# ENDL TEXAS

Date: 14 March 2008  
To: T10 Technical Committee  
From: Ralph O. Weber  
Subject: SPC-4 UML Conventions and CbCS UML Updates

Figure 11 — CbCS overview class diagram

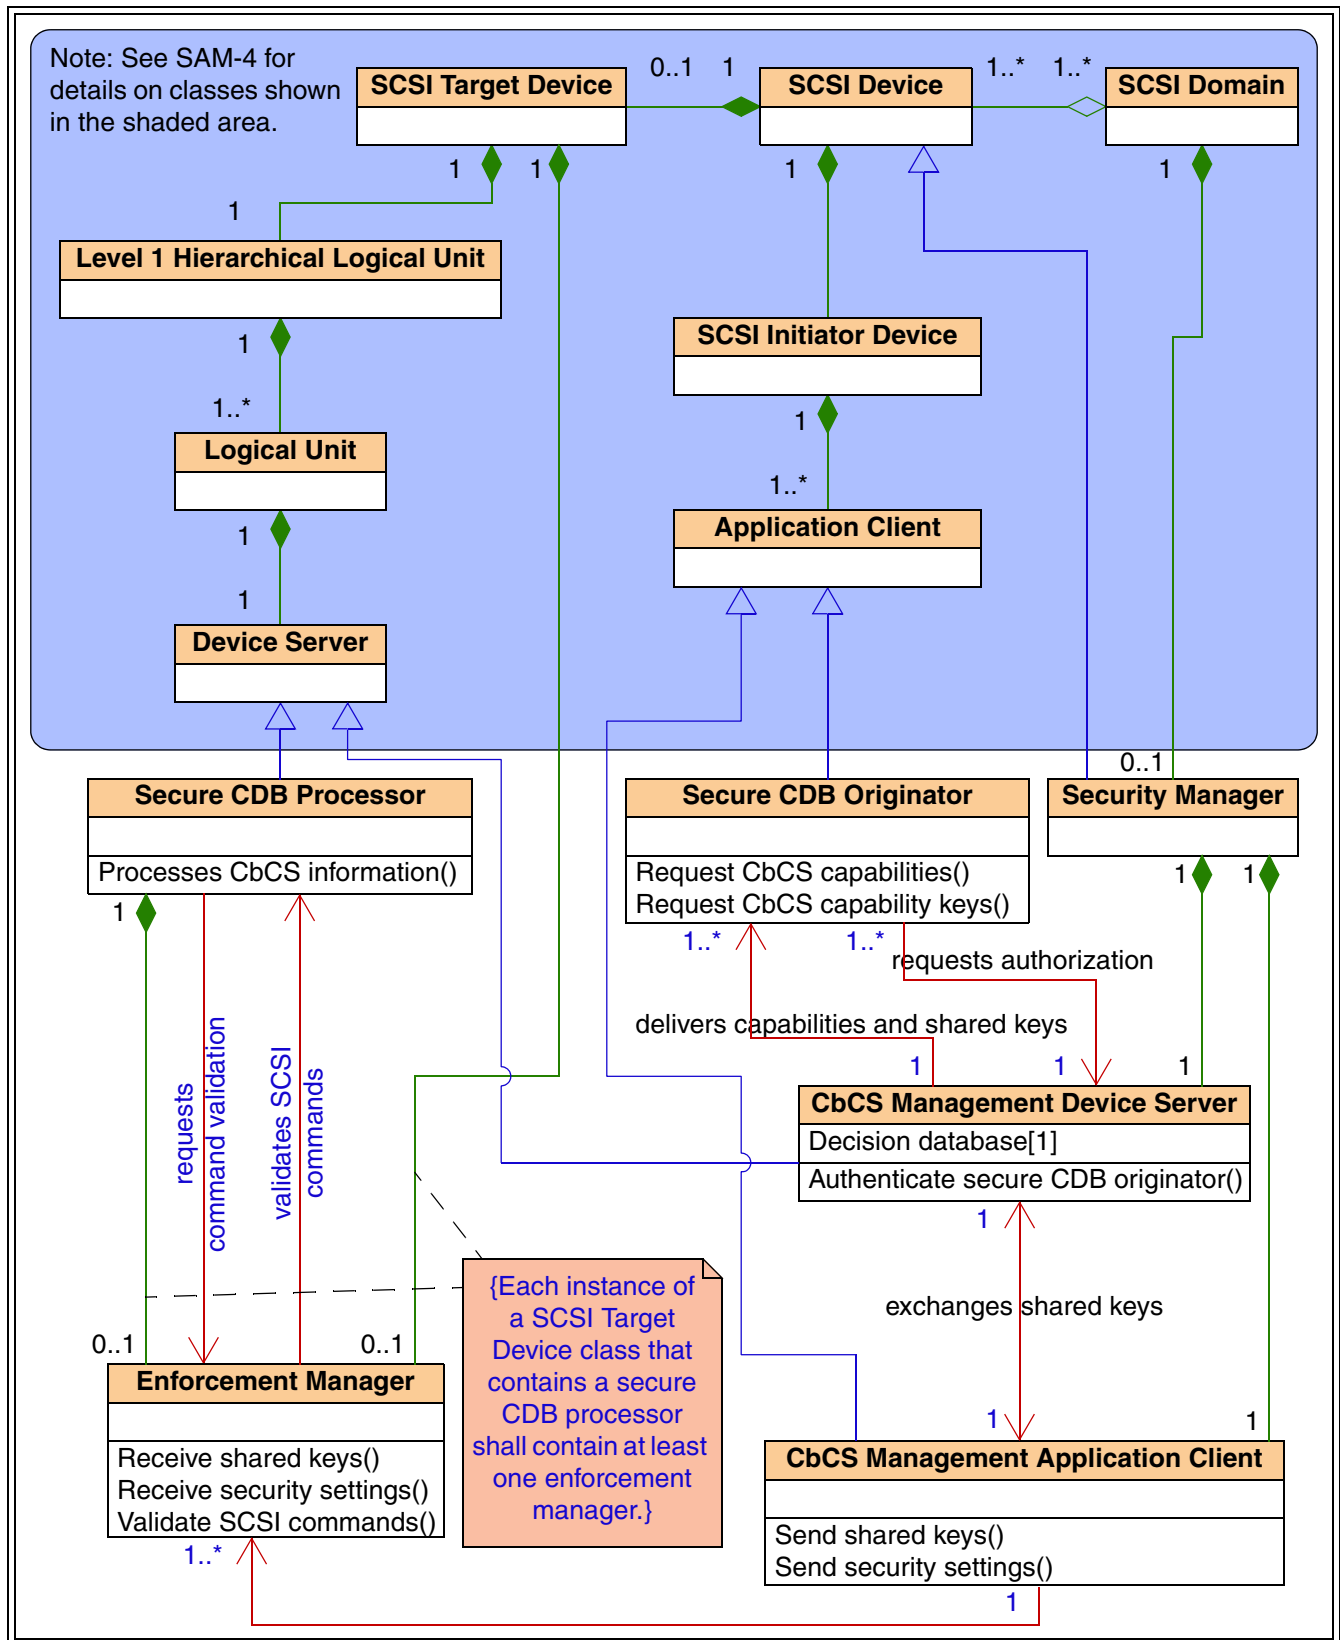
Also, the CbCS UML lacks the required multiplicity notations, and they are proposed here.

- r0 Initial revision
- r1 Revised figure 11 (CbCS overview class diagram) as requested by Sivan Tal and George Penokie. Since change bars do not effectively identify changes in figures, no change bars were added in r1
- r2 Revised as requested by March CAP working group.

Except for figure 11, all changes in this proposal represent new SPC-4 text. In figure 11, additions are shown in blue text, there are no deletions proposed. Comments are shown in green text.
